LAND USE APPLICATION COMPLETENESS REVIEW

Subject Property: 2561 Center Street NE

Ref#: 23-123424-PLN

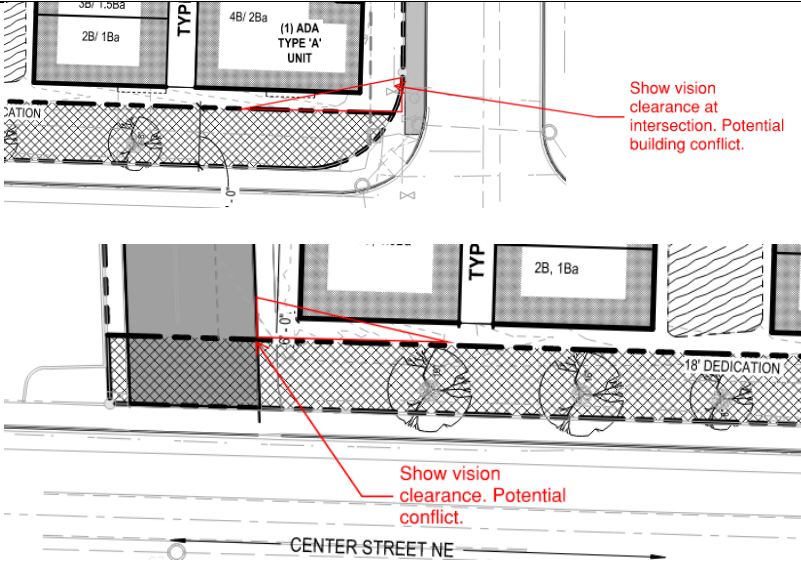
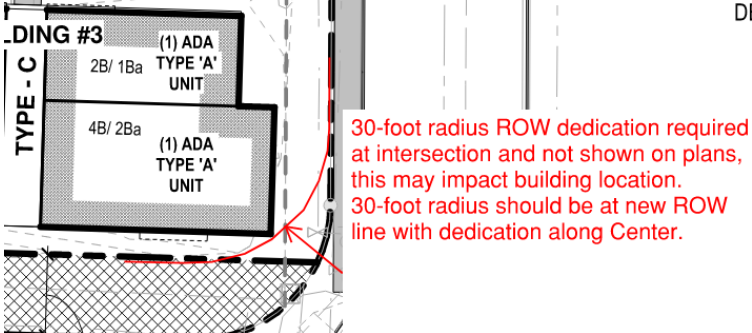
<p>Show vision clearance at intersection. Potential building conflict.</p> <p>Show vision clearance. Potential conflict.</p> <p>CENTER STREET NE</p>
<p>Right-of-way Dedication – Radius (SPR and Partition Submittal Item)</p>	<p>As a condition of building permit approval, the applicant is required to dedicate right-of-way equal to 18-feet from centerline along Center Street NE as well as a 30-foot radius at the corner of Center Street NE and 23rd Street NE. The applicant shall show the radius dedication on the site plan to ensure compliance with setback requirements. Based on the plans submitted, it is unclear if the building at the corner of Center Street NE and 23rd Street NE will encroach into the required dedication area.</p>  <p>30-foot radius ROW dedication required at intersection and not shown on plans, this may impact building location. 30-foot radius should be at new ROW line with dedication along Center.</p>

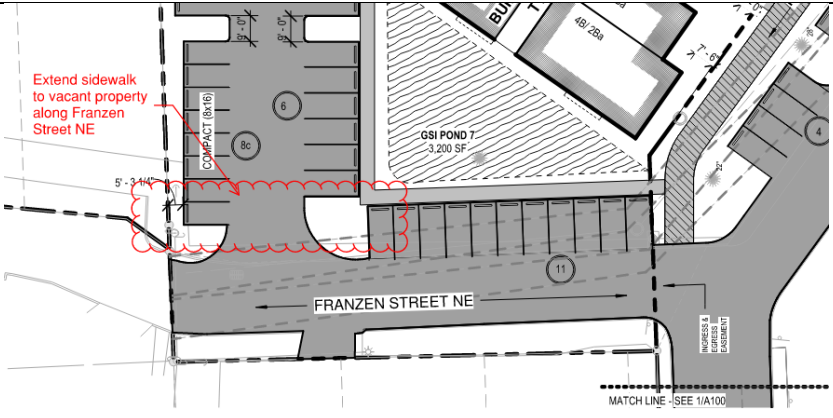
<p>Alternative Street Standard (SPR Submittal Item)</p>	<p>The applicant is proposing a street design that does not conform to SRC Chapter 803 for street standards. The application shall include findings for alternative street standards pursuant to SRC 803.065(a).</p> <ul style="list-style-type: none"> Street spacing and connectivity standards of SRC 803.030 and SRC 803.035(a) are not met. The applicant is proposing to construct a 10-foot wide shared use path through the development site and dedicate an easement

<p>for the path. Staff is supportive of this approach; however, written findings addressing the approval criteria are required. In addition, the plans do not address how connections will be made to existing sidewalks along the northern and southern portions of Medical Center Drive NE. See images below.</p> <ul style="list-style-type: none"> Curbline Sidewalks along 23rd Street SE and elimination of the required planter strip, please see comments under the “Street Tree Removal” section of this letter. Staff is not supportive of this alternative street standard. <div style="text-align: center;">  </div>
Title Report (Partition Submittal Item)	Submit a current title report for the subject properties for review by the Survey Section pursuant to SRC 205.030(b).
Land Division Application Type	According to the Survey Division: The applicant has applied for a three-parcel partition over two single and discrete units of land. Per ORS 92.010, you cannot move a property line with a partition. The applicant can apply for a two-parcel partition for tax lot 4000, then a property line adjustment to get the desired configuration between tax lots 3900 and 4000.

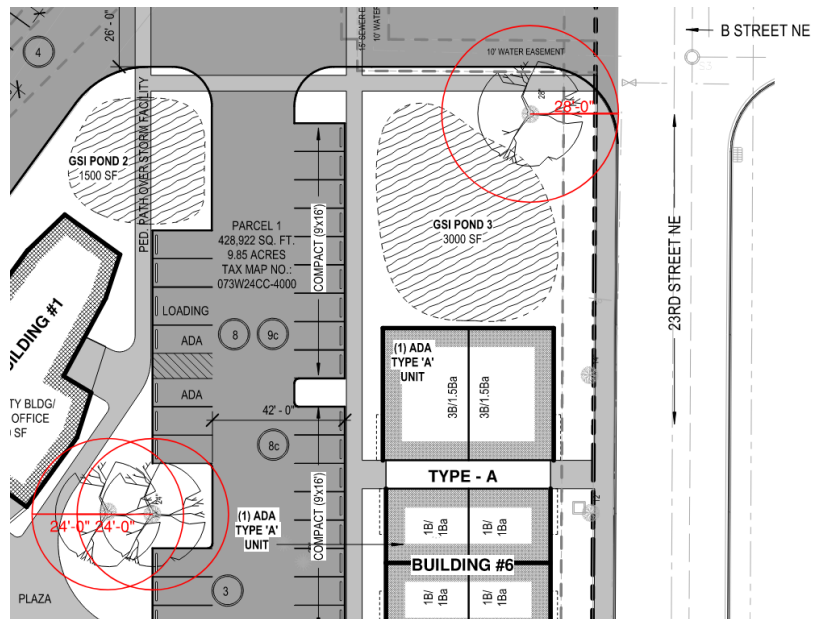
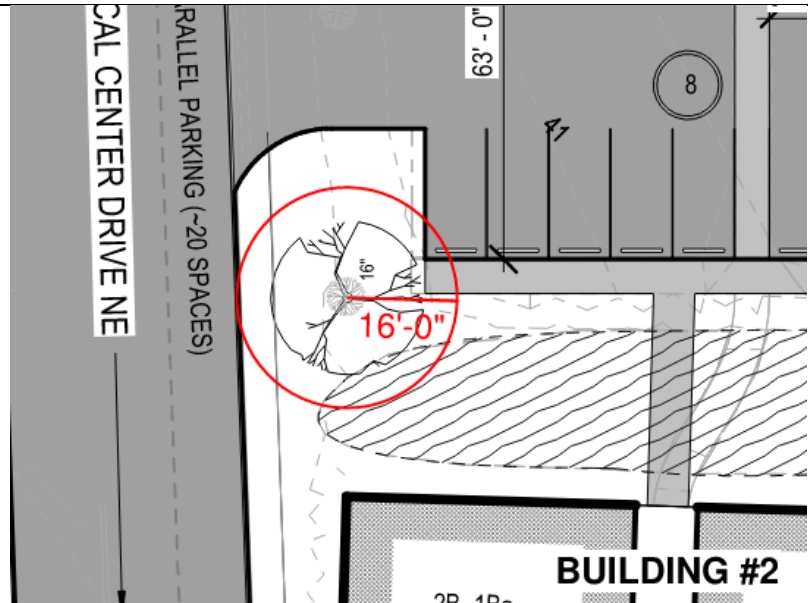
<p>The top diagram shows a plan view of a parking area. A red dashed line outlines a maneuvering path around a 'MAINTENANCE 2' area and a 'COMPACT (8x16)' area. A 'LOT LINE ADJ' is indicated at the top. The bottom diagram shows a plan view of a parking area with a 'BIKE PARKING 3 (36 SPACES)' area and a 'COMPACT (9x16)' area. A red dashed line outlines a maneuvering path. Dimensions of 42'-0", 19'-0", 26'-0", and 16'-0" are shown. Labels '4', '9c', and 'BU' are also present.</p>
<p>Vehicle Use Area Maneuvering Requirements – SRC Chapter 806</p>	<p>Pursuant to SRC 806.035(f)(2), Where a drive aisle terminates at a dead-end, include a turnaround area as shown in Figure 806-9. The turnaround shall conform to the minimum dimensions set forth in Table 806-6.</p>

<p>The maneuvering area provided near Maintenance Building 1 does not comply with the minimum dimensions of Figure 806-9. Please revise the site plan to comply with the minimum standard.</p> 
<p>Landscape Plan and Tree Replanting – SRC Chapter 807</p>	<p>Several trees are proposed for removal from a setback area, and the total number of trees removed from the development site, as calculated under SRC 807.015(d)(2) may exceed 75%, requiring additional replanting of trees.</p> <p><i>Tree replanting requirements.</i> In addition to the landscaping required under this chapter are proposed for removal from within required setbacks or from a development site, replanting shall be required as provided in this subsection. The provisions of this subsection do not apply to lots used for single family uses, two family uses, three family uses, four family uses, or cottage clusters.</p> <p>(1) <i>Removal of trees within required setbacks.</i> When an existing tree or trees within a required setback are proposed for removal, two new trees shall be planted for each tree removed. Replanted trees shall be of either a shade or evergreen variety with a minimum 1.5 inch caliper.</p>

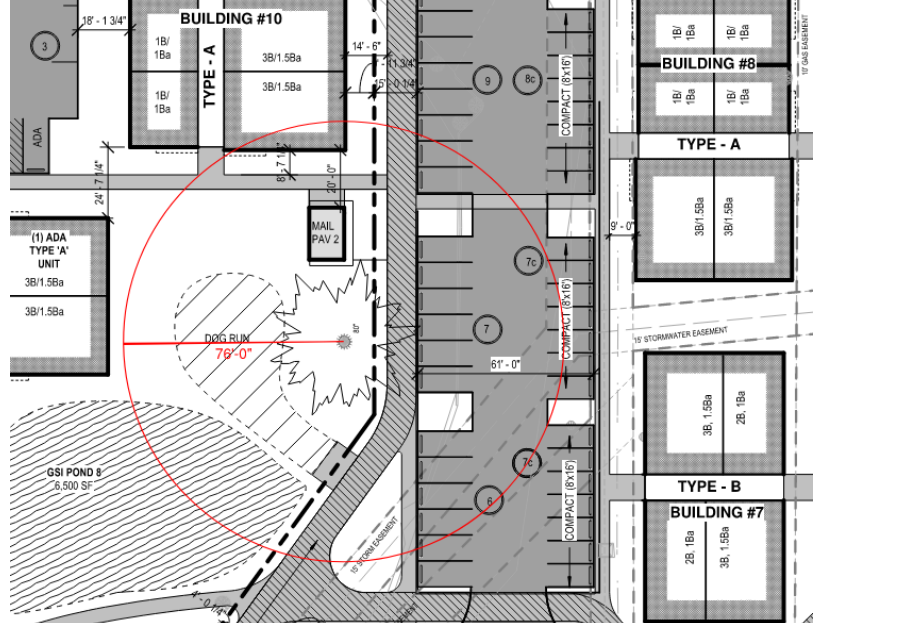
Tree 3602 is a Giant Sequoia with a dbh of 76". The approximate critical root zone is shown below. There is a significant amount of development activity occurring within the critical root zone of this significant tree. Steps should be taken to reduce the amount of grading and development activity in this area, in addition, encroachments into the CRZ will only be allowed following the recommendation of a certified arborist and demonstration that not more than 30 percent of the root zone will be impacted.

<p>The site plan shows a residential development with several buildings labeled: BUILDING #10 (TYPE - A), BUILDING #8 (TYPE - A), BUILDING #7 (TYPE - B), and BUILDING #9. A red circle highlights a specific area on the left side of the plan, near a 'DRAIN' and 'GSI POND 8'. The circle is labeled '76'-0"'. The plan also shows various parking spaces, compact spaces, and easements. A red line indicates a proposed sidewalk or curbline along the street.</p>
<p>Curbline Sidewalk along 23rd Street SE</p>	<p>The application is proposing the removal of at least 15 City-owned trees along 23rd Street SE in order to place curbline sidewalks along 23rd Street SE. The Salem Transportation System Plan standard cross section for a collector street requires a minimum 6-foot-wide planter strip with sidewalks placed behind the planter strip. Staff is not supportive of removal of the City owned trees along 23rd Street or an alternative standard to allow curbline sidewalk.</p> <p>Staff recommends that the sidewalk be placed behind a planter strip of appropriate width that can accommodate the existing trees and additional trees to be planted along 23rd Street SE and provide a pedestrian oriented environment, which is intended within the Mixed-use Zones. A public access easement will be required for the sidewalk to be placed on private property.</p>
